Leighton Consulting, Inc.
A LEIGHTON GROUP COMPANY

Project No. 11672.001

**Subject: Geotechnical Review
Mount San Antonio College South Campus-West Parcel
West of Grand Avenue and Approximately 500 Feet Southeast of
Temple Avenue/Amar Road
City of Walnut, California**

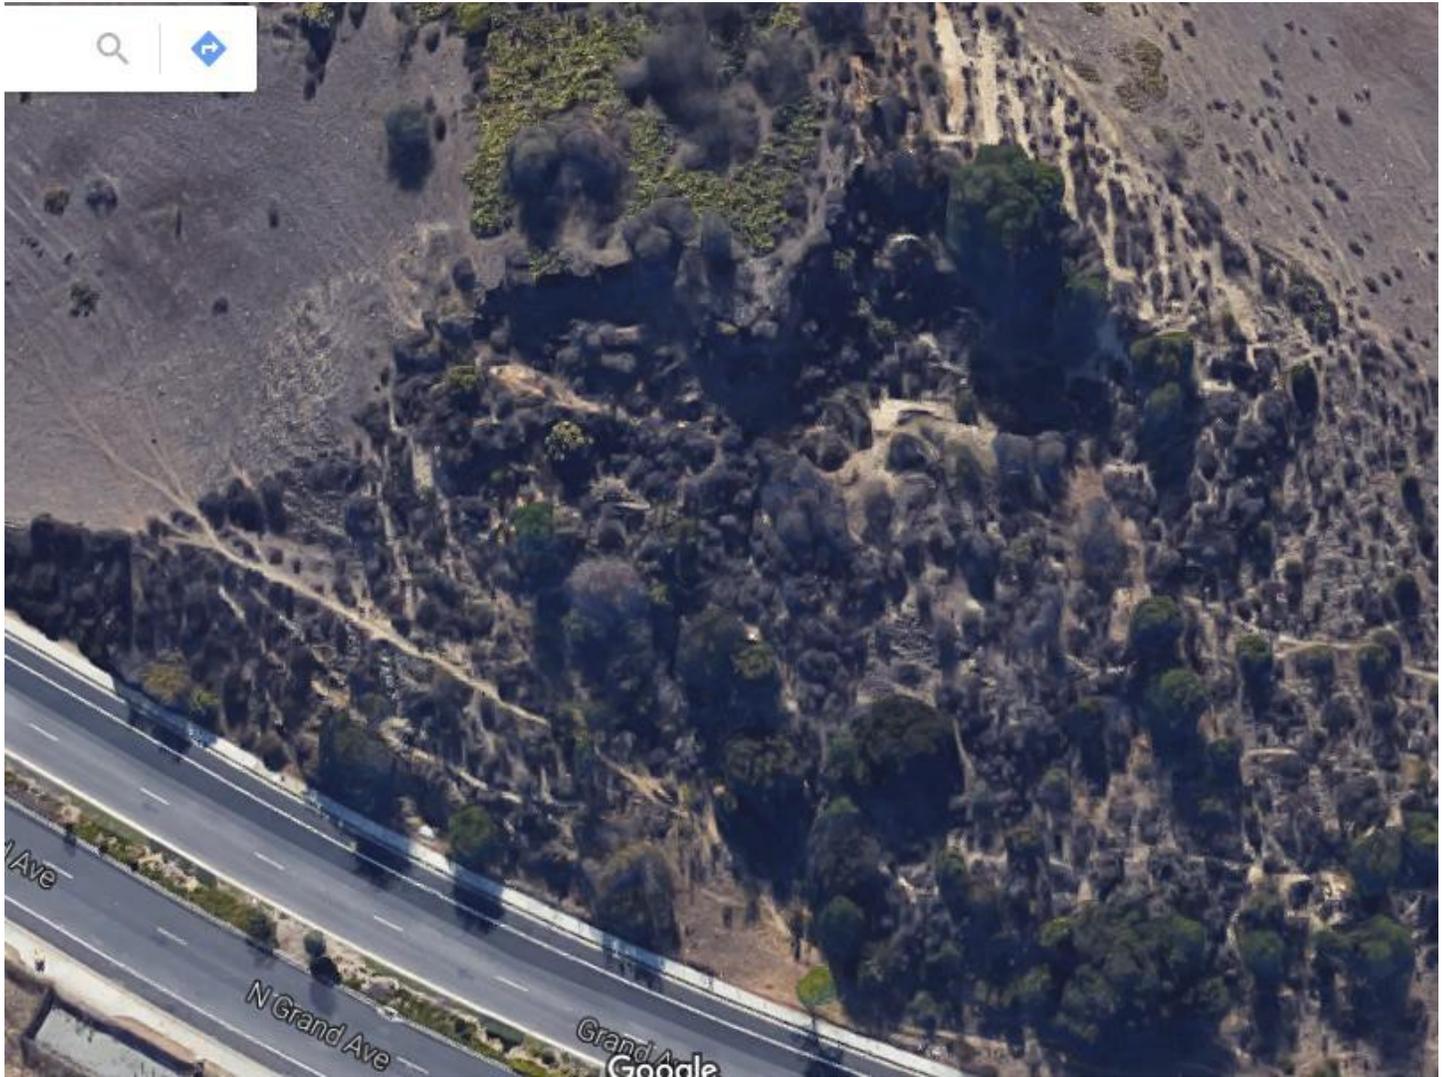
i. The landslide at Grand Avenue occurred about 1980 shortly after Grand Avenue was widened to four lanes in the late 1970's, likely from the undercutting of the central hill near the roadway.

ii. Homes on Regal Canyon Drive were built between 1980 and 1995, separated by about 0.15 miles from the central hill by an intervening canyon.

iii. The proposed project grading would undercut hillside slopes north of these homes by up to 40 feet, potentially causing similar landsliding along out of slope bedding planes.

See Section 2 (Preliminary Findings) in Leighton's geotechnical review

See Section 2 (Preliminary Findings) in Leighton's geotechnical review
